SNDR:

Suggested resolution to comments: #64, #84, #121, **#122,** #123, #124, #136, #139, #147, and #153.

COM for Different Tx_SNR values

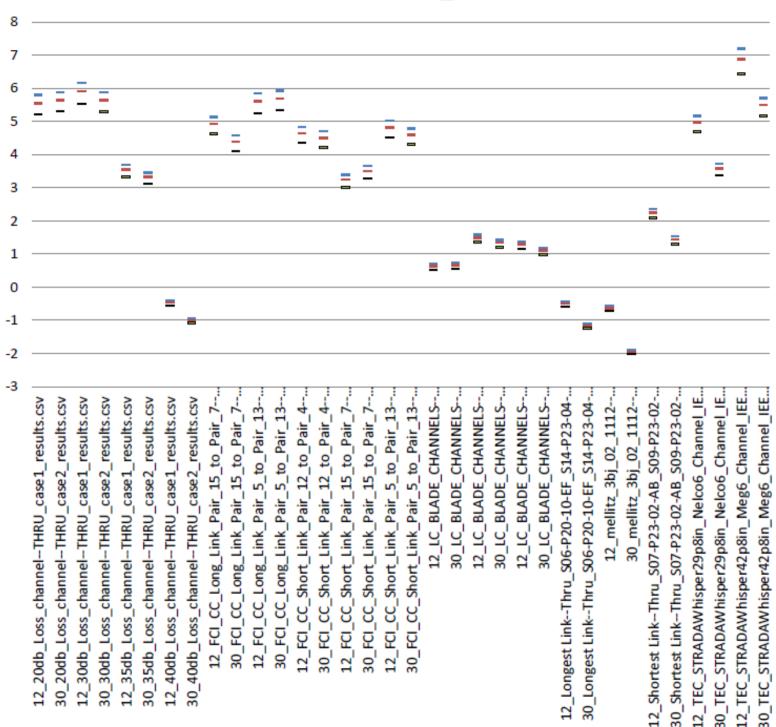
Rich Mellitz reports that changing SNR_{TX} from 29 dB as in D2.2 to 27 dB produces ~0.3 dB or less change in COM for all channels in his COM regression test suite with the amount of change much smaller for channels near the 3dB limit.

The spec is SNDR ≥ 27 dB

The COM parameter SNR_{TX} is set to the specified SNDR
